10 E. AUBURN ROAD
ROCHESTER HILLS, MI 48307
CLEAN
EXPRESS AUTO WASH

SITE PLAN FOR
CLEAN EXPRESS CAR WASH
 10 E AUBURN ROAD
 ROCHESTER HILLS, MI 48307

Site plan.pdf Markup Summary

**CLEAN EXPRESS CAR WASH - ROCHESTER HILLS, MI
SITE LIGHTING LAYOUT**

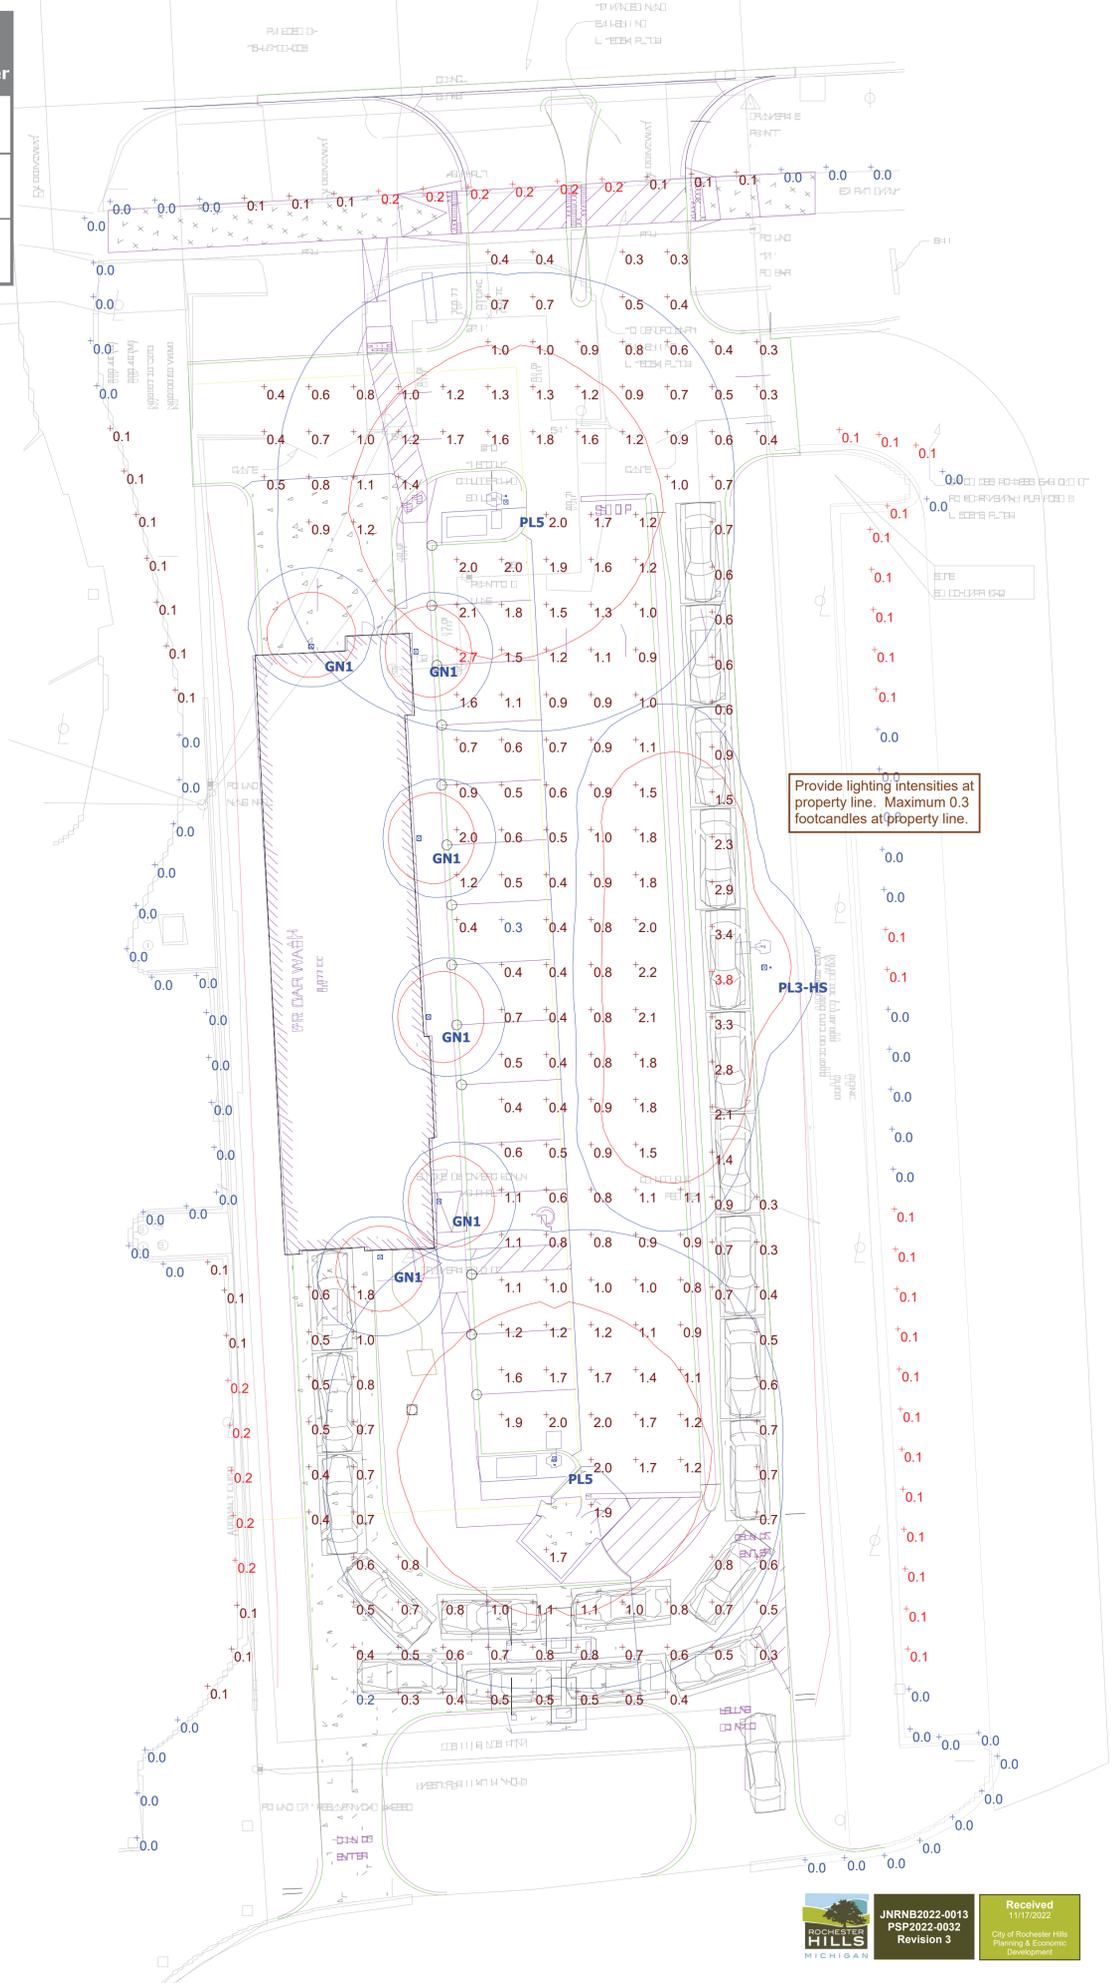
Provide lighting intensities at property line. Maximum 0.3 footcandles at property line.
